DOCKETED	
Docket Number:	11-AFC-04
Project Title:	Rio Mesa Solar Electric
TN #:	233564
Document Title:	Applicant's Supplemental Response to Data Request 16 and 26 Additional Information Regarding Land Use
Description:	Document was on proceeding webpage and is now moved over to the docket log.
Filer:	Marichka Haws
Organization:	California Energy Commission
Submitter Role:	Commission Staff
Submission Date:	6/19/2020 3:35:41 PM
Docketed Date:	6/19/2020

APPLICANT’S SUPPLEMENTAL RESPONSE TO DATA REQUEST 16 AND 26: ADDITIONAL INFORMATION REGARDING LAND USE

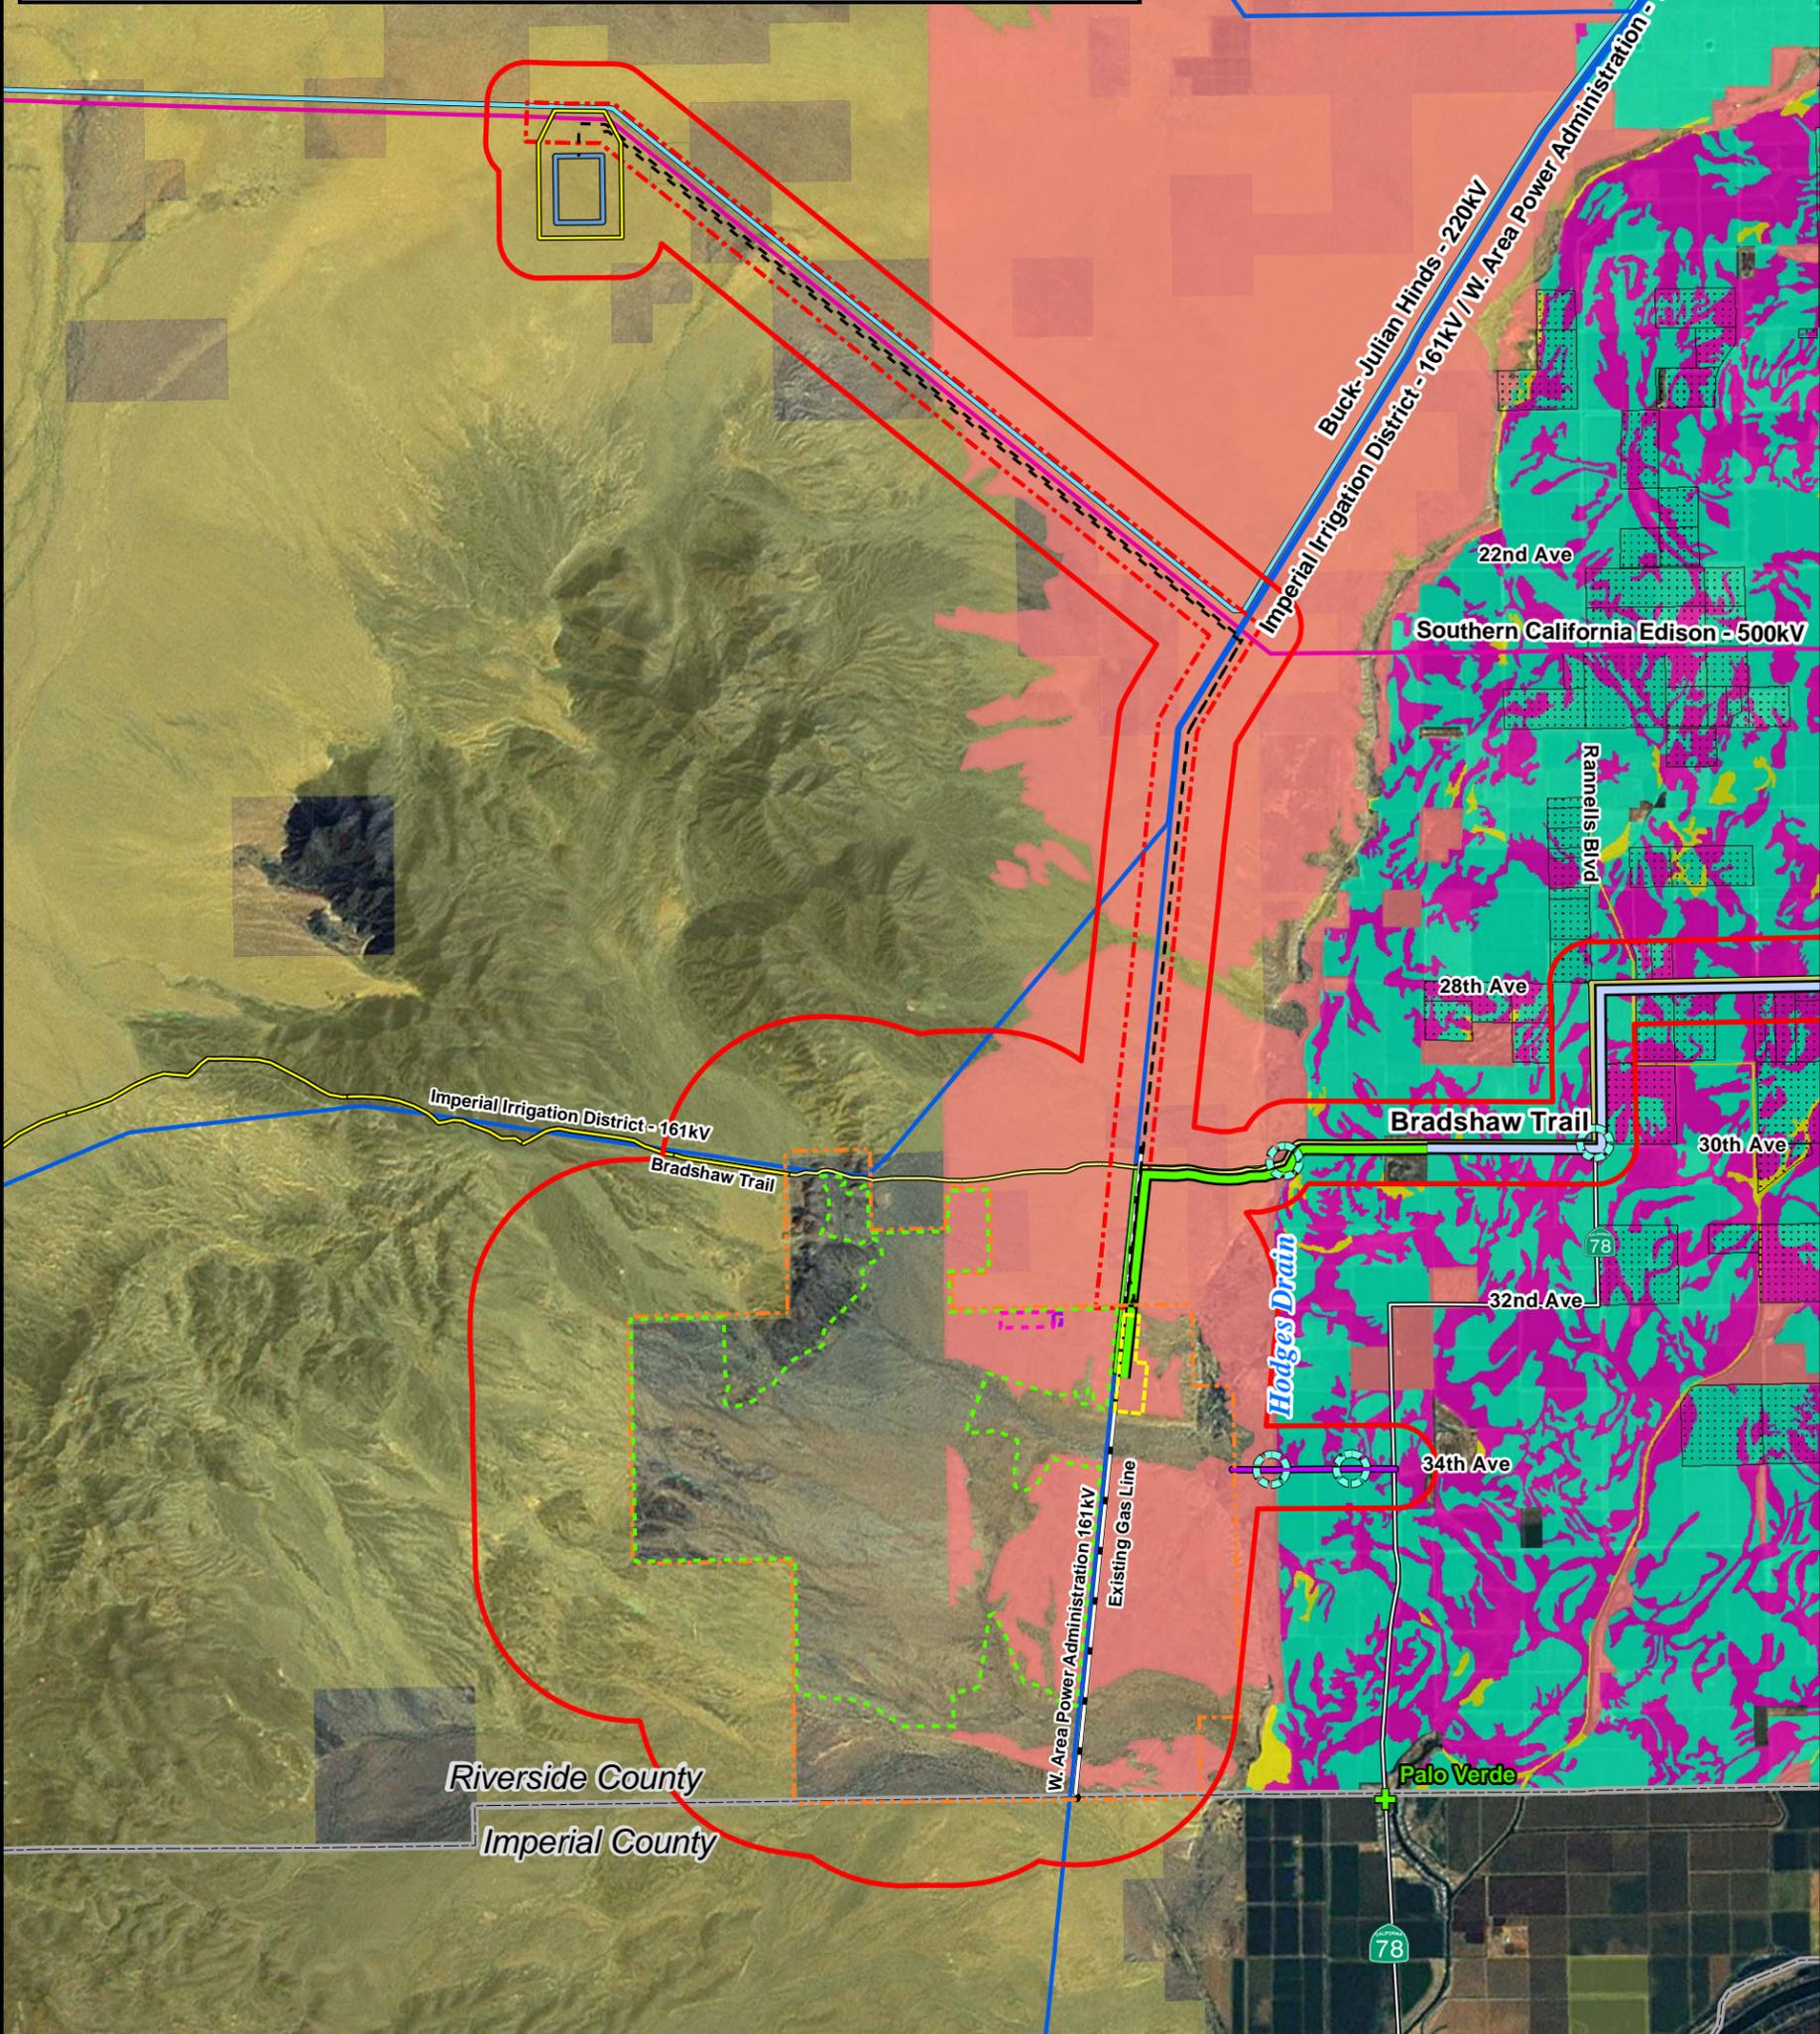
The 0.25 mile Study Area for the 34th Avenue project access road, as indicated on Figure 5.6-3 (rev), is ~~primarily partially covered~~ within the one-mile project site Study Area. The remainder of the 34th Avenue access road Study Area is included in Table 5.6-6. This was done to avoid double-counting effects to agricultural land from the project site Study Area and the 34th Avenue Study Area boundaries. The Study Area for Bradshaw Trail access road improvements, as indicated on Figure 5.6-3 (rev), is entirely covered in the 0.25 mile Study Area for the proposed 33 kV service line, and, therefore is not included or counted in Table 5.6-6. The Study Area for Bradshaw Trail access road improvements and the portion of this linear that follows alongside the 33 kV service line Study Area, are evaluated as one linear corridor with the same Study Area.

Table 5.6-6 and Figure 5.6-3 (rev) indicate the designation of farmland within the Study Area.

transmission line that runs along Bradshaw Trail to State Route 78. From here, the overbuild portion of the service line will parallel State Route 78 until it reaches South Neighbors Boulevard (see Figure 5.6-3 (rev)). The entire distance of the overbuild portion of the service line is approximately 5.1 miles. The Study Area for the approximate 3.12 mile portion of the service line that requires construction of a new line affects parcels with Prime Farmland, Farmland of Statewide Importance, and Unique Farmland designations. Construction of new transmission structures is proposed adjacent to an existing road and will not directly impact farmlands. Construction of new transmission structures may indirectly impact these farmlands through temporary construction staging. The portion that requires Bradshaw Trail access road improvements (paved or unpaved) may indirectly impact these farmlands through increased vehicle trips on this road. The impact to agricultural land from the portion of the 33 kV service line that requires new construction and Bradshaw Trail access road improvements is anticipated to be less than significant. The Study Area for the remainder of the service line that requires overbuild of an existing transmission line affects parcels with Farmland designations. However, this portion is simply an upgrade and requires no new structures, and therefore, will result in a finding of no impact.
